T.I. no.: 2015-03-b Updated: 16.02.2015	Topic: Steam nozzles
----------------------------------------------------------	-----------------------------

Date: 22/01/2015
Affected machines: SCP
From serial number: 1510...
From date: Calendar week 10

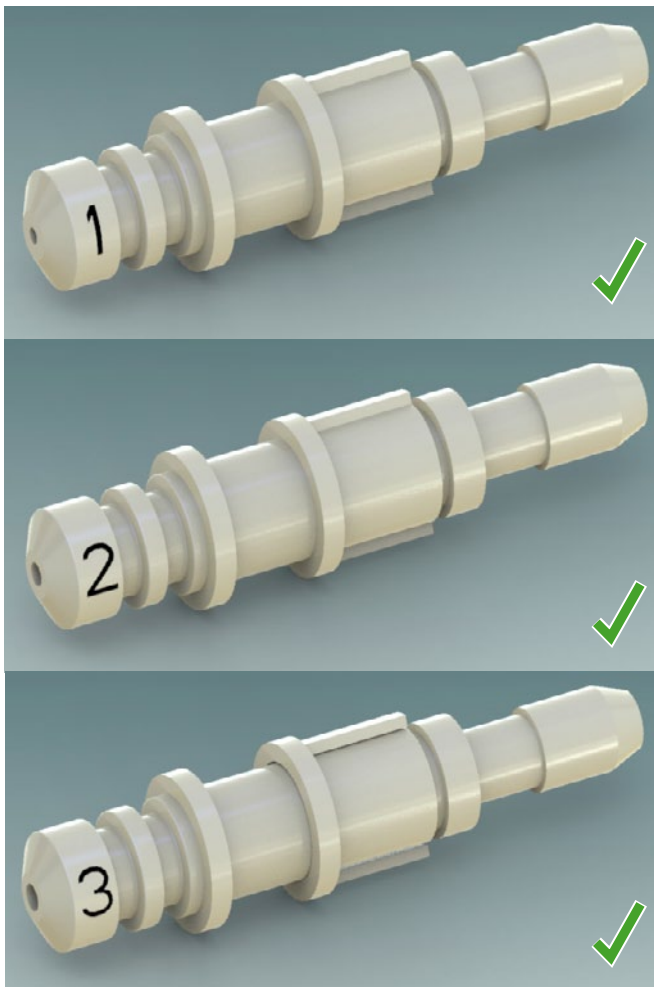
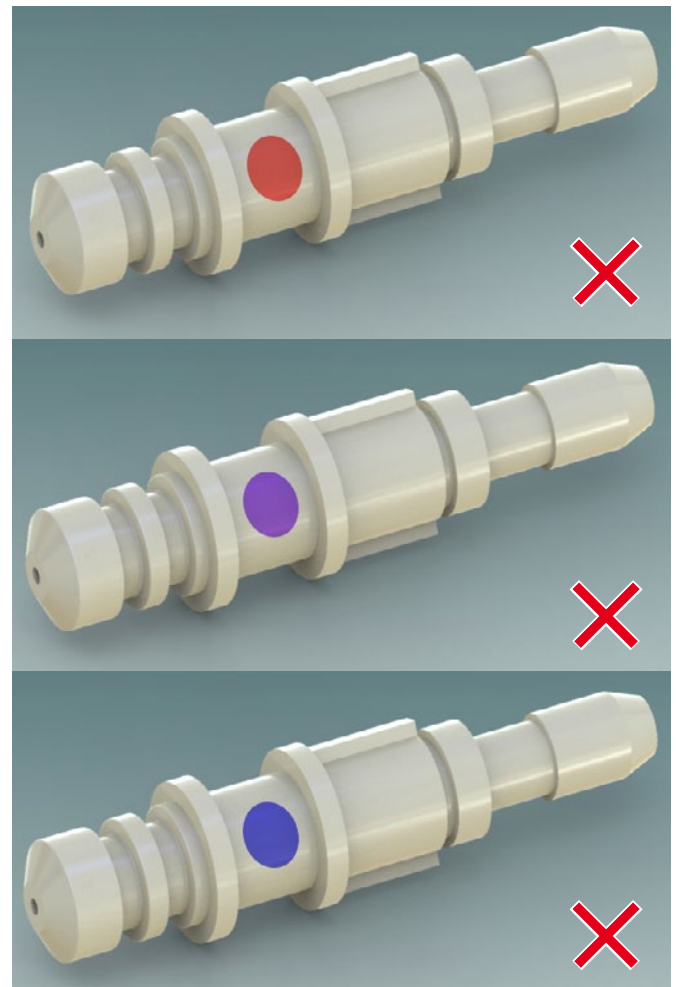
To allow unambiguous identification of the steam nozzles, numerical designations will now be used in place of colour markings. The numbers will be engraved on the steam nozzles.

The article numbers of the steam nozzles have not changed. Starting in calendar week 10, only steam nozzles with engravings will be installed at the factory.

Steam nozzles with engraving

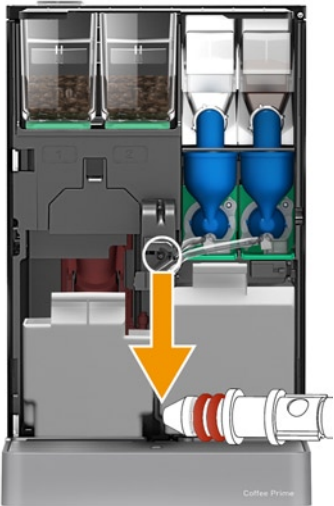
For SCP machines with the Powerpack option (2 kW and 3 kW models), we generally recommend switching over to the new engraved steam nozzles in order to prevent possible variations in the quality of hot milk foam.

The new steam nozzles can be ordered free of charge from Sales SAG starting in calendar week 10. A serial number must be included with all orders.
